**CERTIFICATE OF COMPLIANCE
FOR RADIOACTIVE MATERIAL PACKAGES**

**SAFETY EVALUATION REPORT
Docket No. 71-9362
Model No. DN30 Package
Certificate of Compliance No. 9362
Revision No. 5**

By letter dated April 3, 2024 (Agencywide Documents Access and Management System Accession No. ML24094A002), Orano NCS GmbH submitted an amendment request for the Model No. DN30 package.

Figure 2.1. (a) Valve Protecting Device (VPD) without Housing, and (b) VPD with Housing

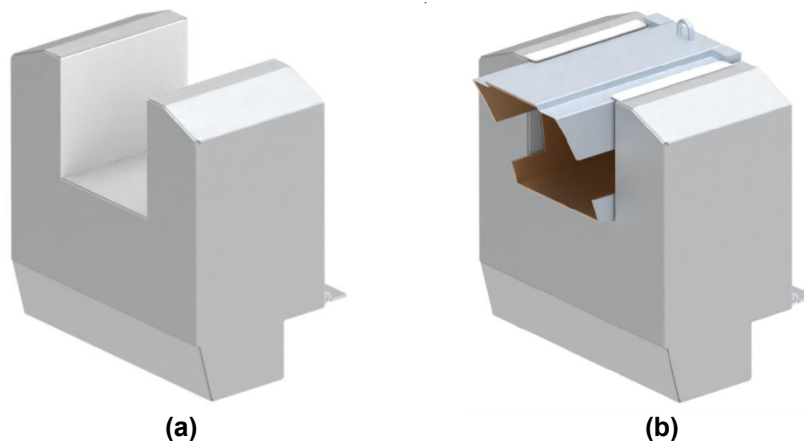
The proposed design change is to remove the housing of the valve protecting device from the design of the DN30 package to improve its structural safety.

In addition, the VPD has a design feature of a housing that can be inserted into the VPD. The housing is shaped like a “box” and is made of 0.04 inch (1 mm) thick stainless-steel sheet. It is designed to provide support for placing the intumescent material and improve the thermal conditions in the VPD during the thermal tests.

The applicant stated that the VPD did not use the housing during the structural drop tests presented in the SAR, Rev. 1, which were previously reviewed and accepted by the NRC staff. However, during the second (September 2016) and third (November 2017) experimental thermal tests after the drop tests, the housing was placed into the VPD. The housing was covered on the inside with intumescent material with the intent of improving thermal safety conditions to prevent hot gases from reaching the valve during the thermal tests.

However, the applicant found that the microporous insulation layer added to the PSP design during the third and final experimental thermal test was efficient regarding the thermal protection of the 30B cylinder and, as a result, the housing of the VPD was not needed to improve thermal safety conditions.

Therefore, the applicant decided to remove the housing of the VPD from the PSP and proposed the design change of removing the housing in this application.

The applicant stated in appendix 2.2.1.3, "Structural Analysis of the DN30 Package under NCT and HAC," of the SAR that the housing of the VPD was not used during the previous structural drop tests. The housing of the VPD was only used during the second and third experimental thermal tests. Therefore, there are no changes in the results of the structural drop tests by the removal of the housing of the VPD.

The applicant described in section 2.1.4.2.8.1 of the SAR that the DN30 PSP cylinder valve protective device housing (a box-shape made of 1-mm thick stainless steel covered internally with intumescent material) that was used in the mechanical tests and thermal tests was removed from the design because it provides no significant thermal safety benefit.

The applicant further described that while the housing was designed to keep hot gases from reaching the valve, the microporous insulation layer that has been part of the DN30 PSP design for the third (and successful) experimental thermal test provides sufficient thermal protection, and therefore the housing was no longer necessary.

The NRC staff reviewed the licensing drawings with tolerances and dimensions, component descriptions, and arrangement of the components relative to each other. Additionally, the NRC staff reviewed the results of the model tests and structural FE analyses. Based on these reviews, the NRC staff confirmed that the applicant's statements are accurate and agreed with its conclusion that the removal of the housing from the VPD does not affect the structural performance of the DN30 package under NCT and HAC.

Therefore, the NRC staff determined that the applicant's proposed design change of the removal of the housing from the VPD is acceptable and concludes that the DN30 package without the housing of the VPD will perform its intended structural functions under NCT and HAC.

The staff reviewed the valve protecting device, Drawing No. 0023-ZFZ-1140-000 rev. 4, to verify that the box-shaped housing was removed. The staff finds that because the housing was designed to keep hot gases from reaching the valve, and there are no hot gases during routine conditions of transport and NCT, it is acceptable to remove the housing for NCT. The staff also finds, based on its review of the applicant's evaluations described in this section of the SER, that it is acceptable to remove the housing for HAC.
